RADIOLOGIC AND ENGINEERING ASSESSMENT

DOE ID NO.: GJ-11061-RS  
ADDRESS: 419 BELFORD AVENUE

URANIUM MILL TAILINGS REMEDIAL ACTION PROJECT OFFICE

The following is in response to your questions and comments during the Technical Review concerning Department of Energy (DOE) Identification (ID) number GJ-11061-RS, conducted 11 April 1985.

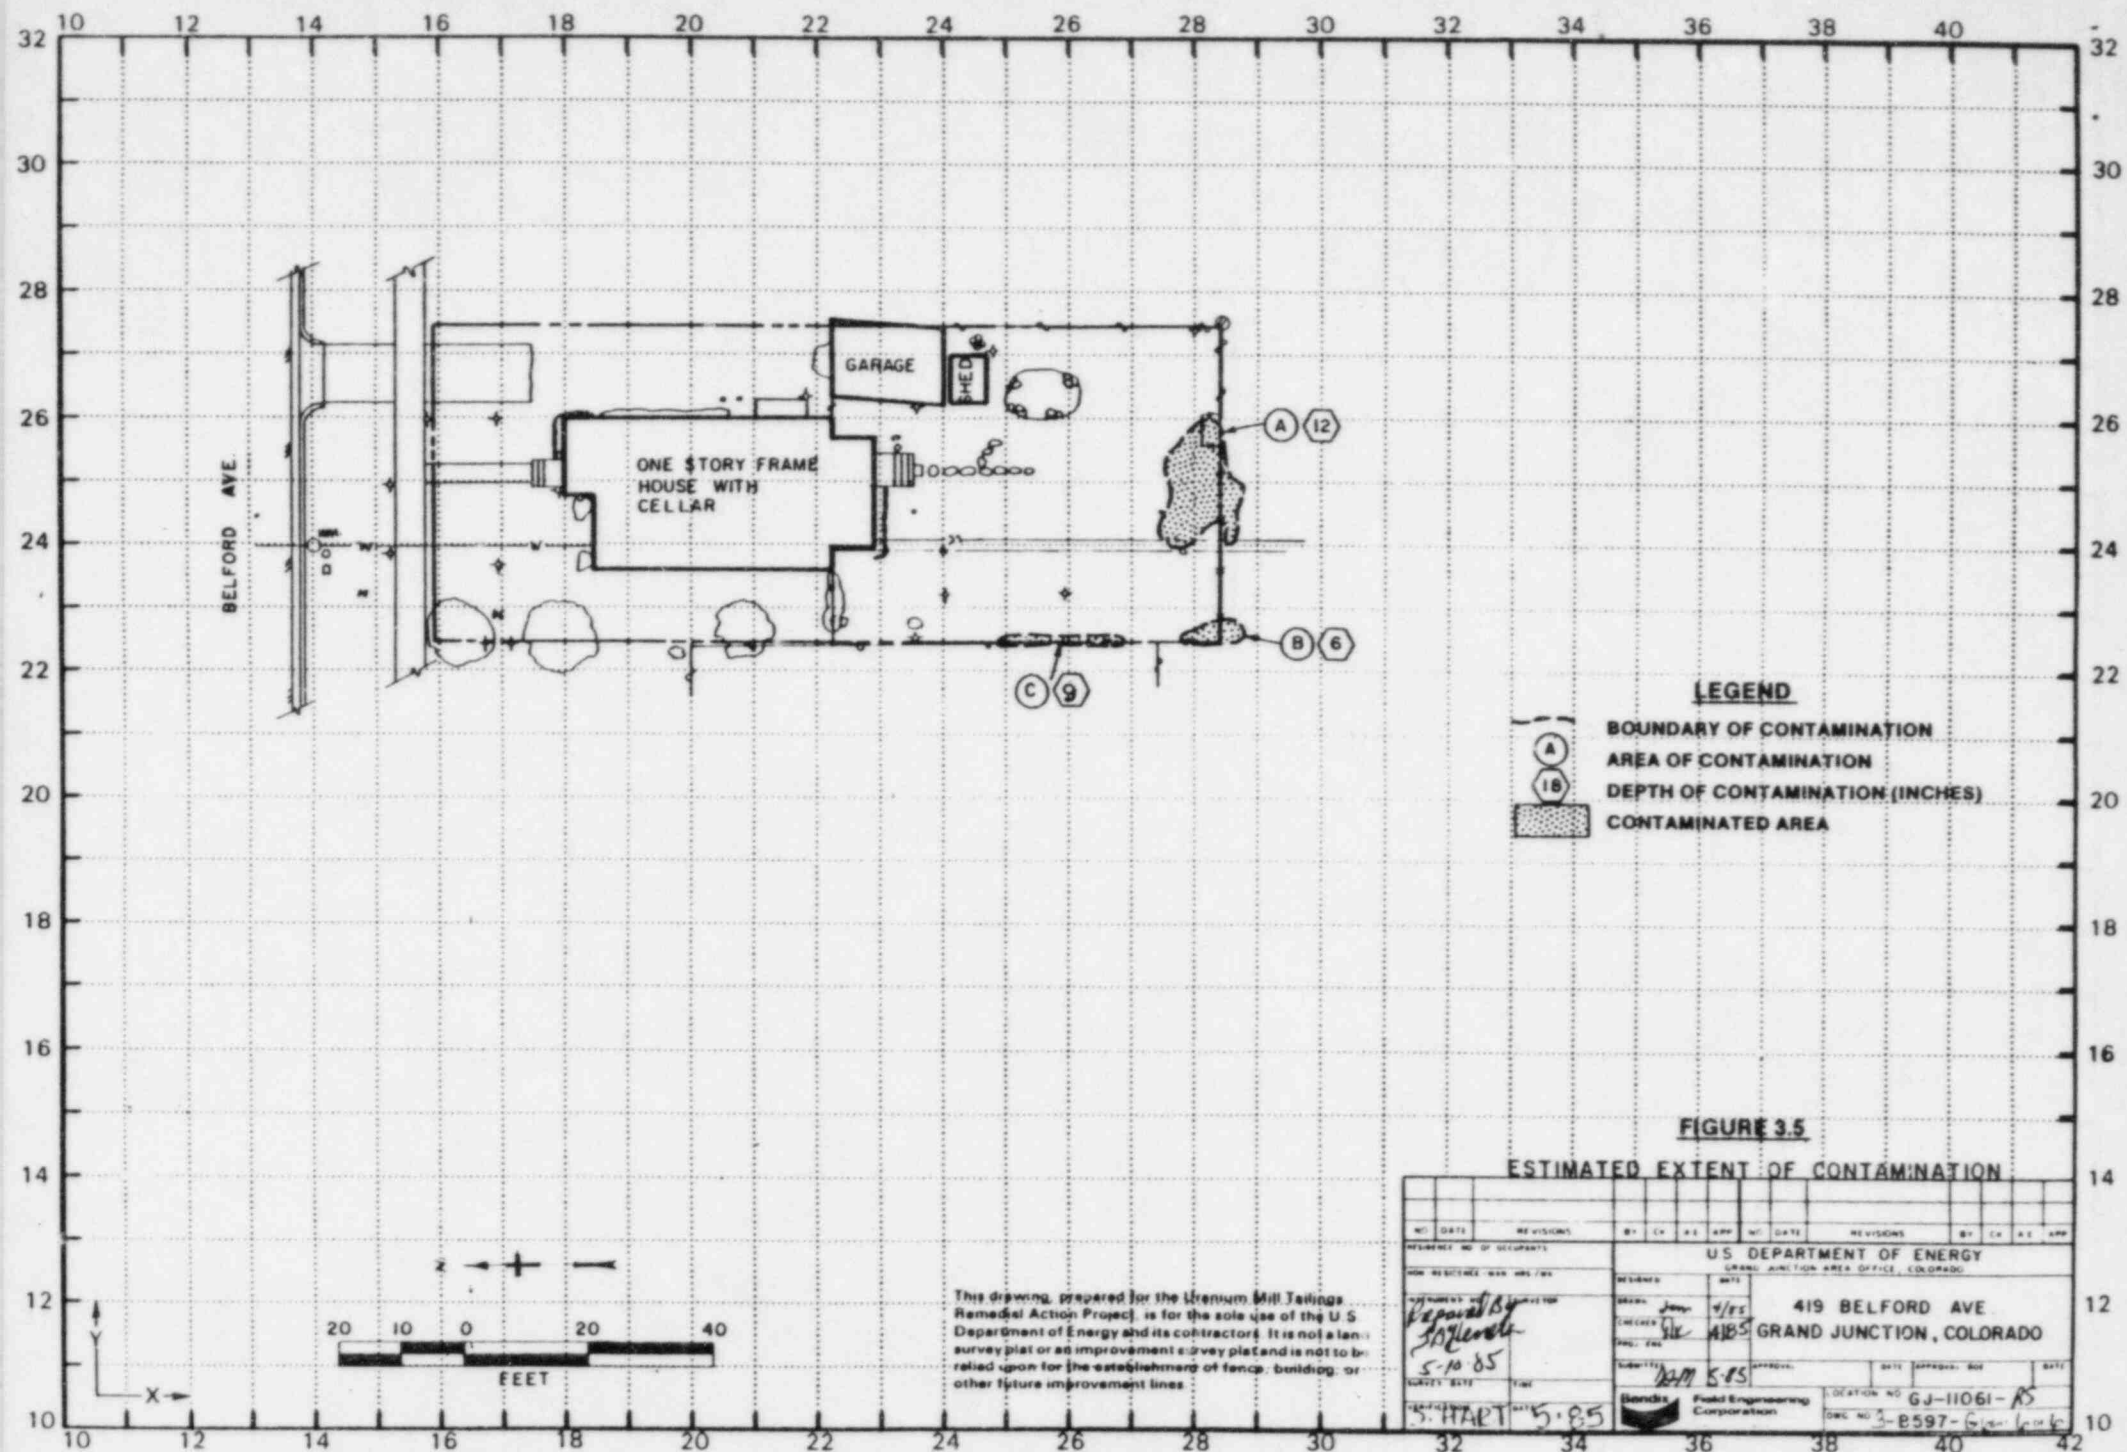
4. Based on all available data, the depth of contamination is 6 inches at the backyard west fence line, Locations 8, 10, and 15. The estimated extent of contamination map (Figure 3.5) preliminary map was changed to 6 inches at these locations along the fence line.
